PERMIT

SEWAGE DISPOSAL SYSTEM
HOWARD COUNTY HEALTH DEPARTMENT
BUREAU OF ENVIRONMENTAL HEALTH
410-313-2640

P 514719
A 30976
ISSUE DATE 12/22/2000
APPROVAL DATE 5/29/01

ADDRESS 11723 Legore Bridge Road, Keymar, MD 21757 PHONE 301-898-0955
SUBDIVISION Flamewood LOT NUMBER 6 ADDRESS 11505 Blue Flame Court
PROPERTY OWNER Ward PROPERTY OWNER'S ADDRESS 8468 Woodland Manor
SEPTIC TANK CAPACITY 1250 GALLONS Top Seam
PUMP CHAMBER CAPACITY 1250 GALLONS (Top Seamed Tanks)
NUMBER OF BEDROOMS 4
SQUARE FEET PER BEDROOM 180
LINEAR FEET OF TRENCH REQUIRED 240

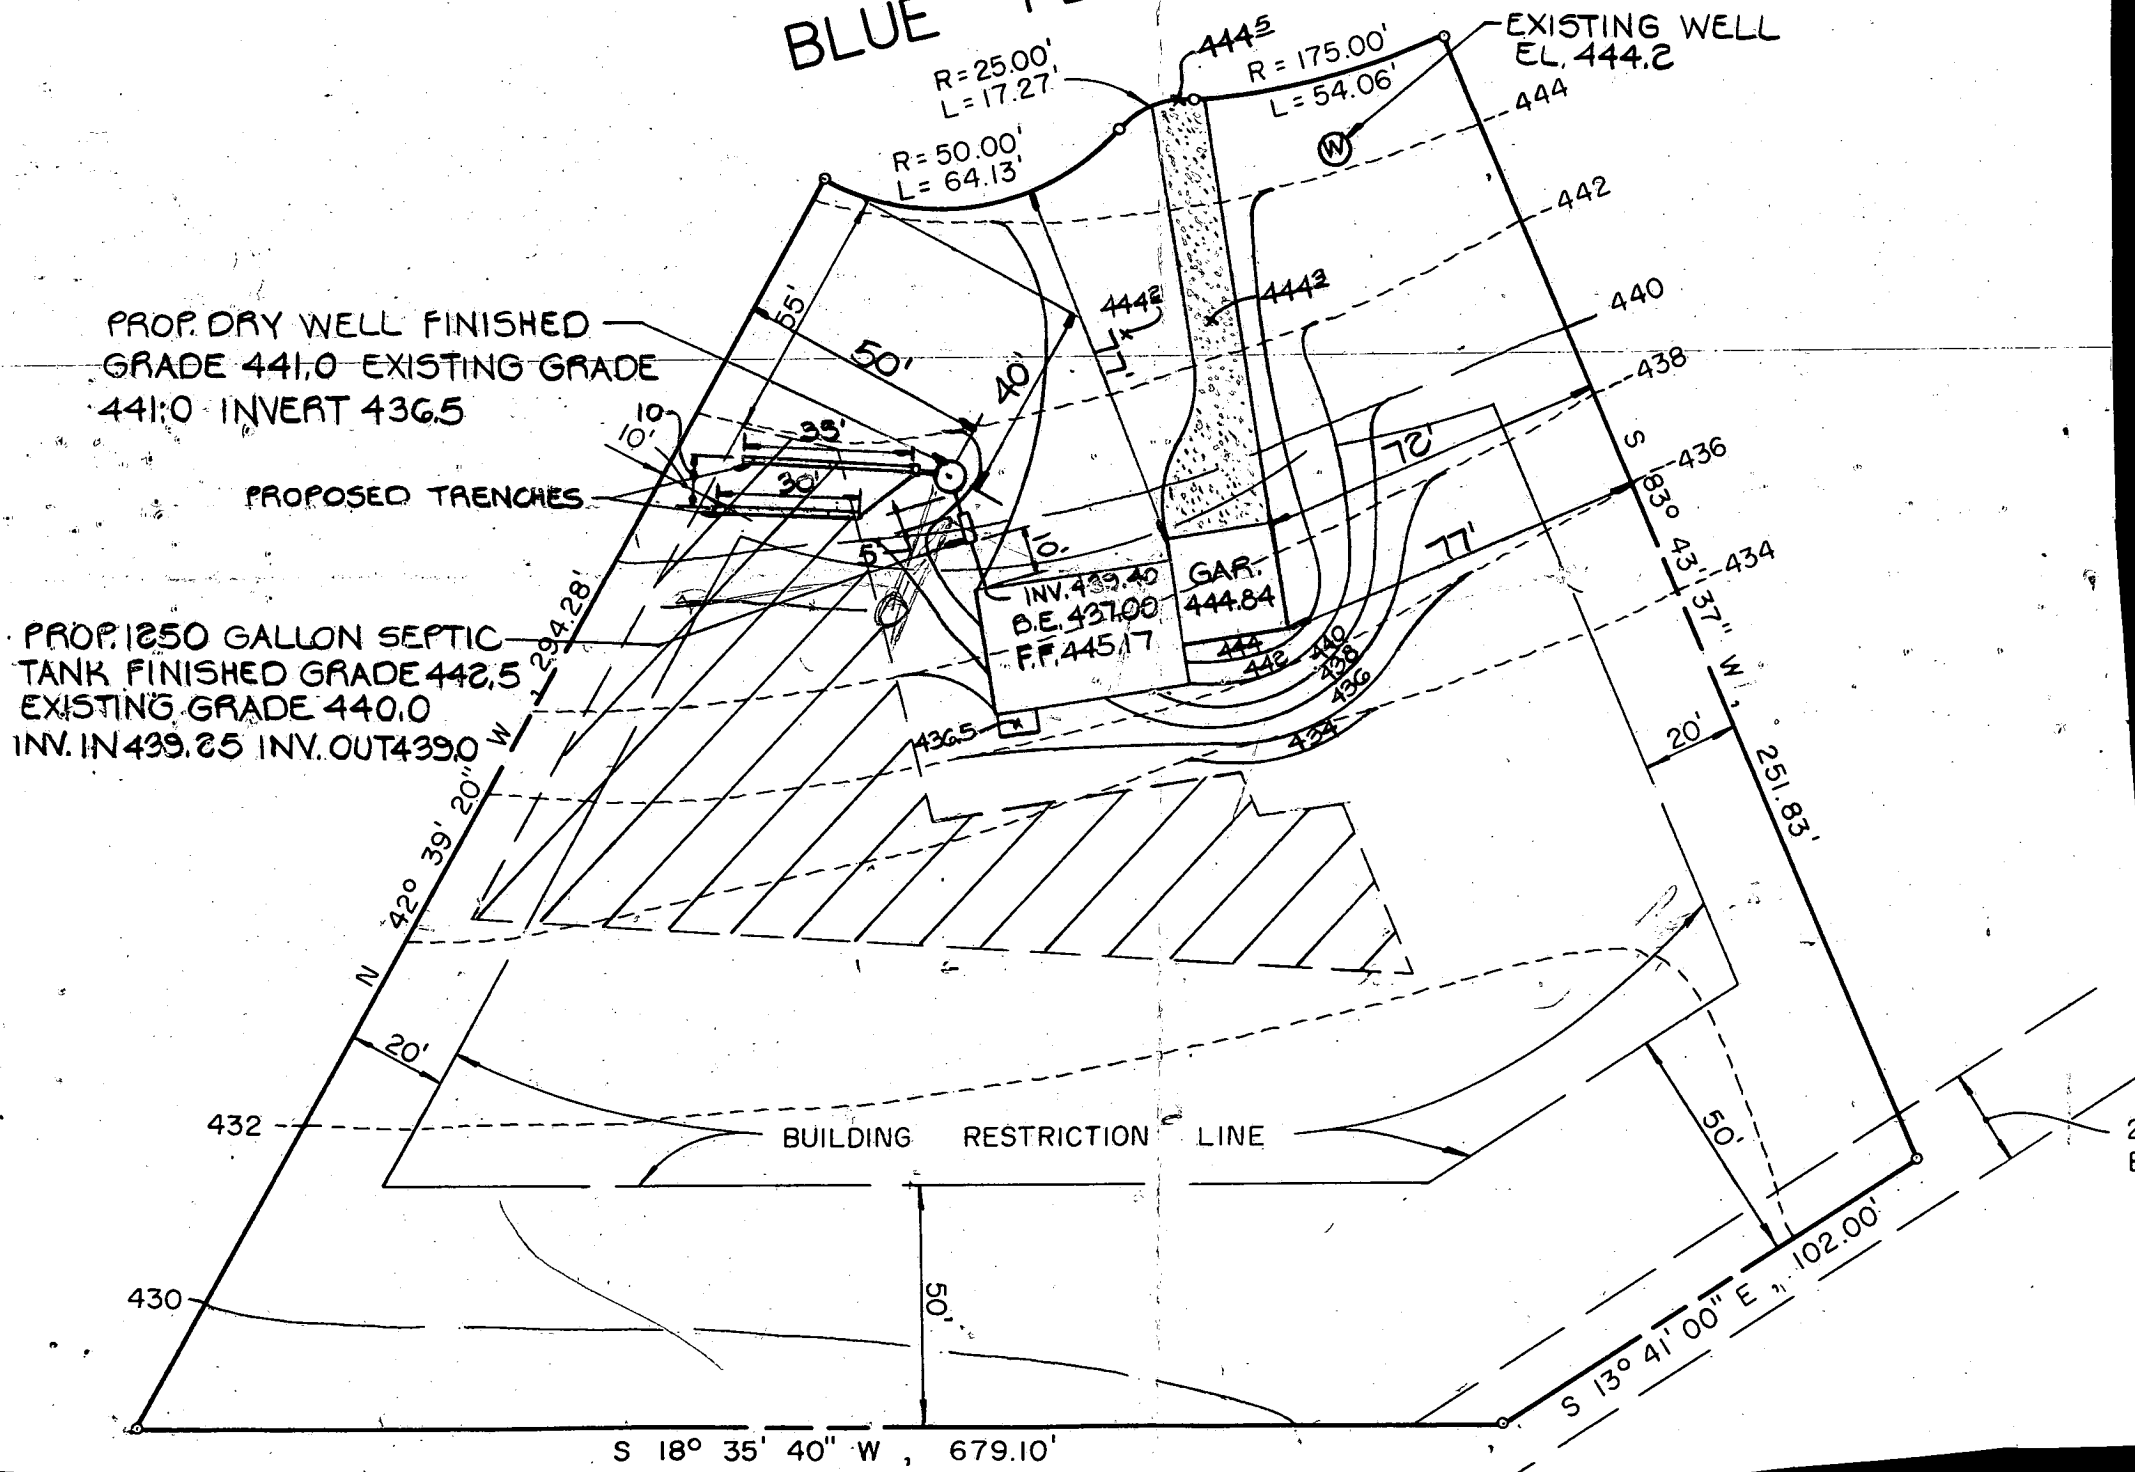
PRE-CONSTRUCTION INSPECTION: 12/27/00 SDA not staked - unable to confirm layout. Upper portion of SDA may have been cut.

INSPECTION COMMENTS: Contractor to get SDA staked for re-insp. DKS

1/21/01 A.M. Spoke to installer - he reports ~2' fill dirt over upper portion of SDA. OK to install system as specified - installer reports clear indication of end of fill. DIC

12/29/00 SDA staked - trench layout confirmed. DIC

1/3/01 COVER TANKS + TRENCHES, HOLD FOR PUMP/ALARM INSP (MR)

5/29/01 PUMP/ALARM OK (MR)
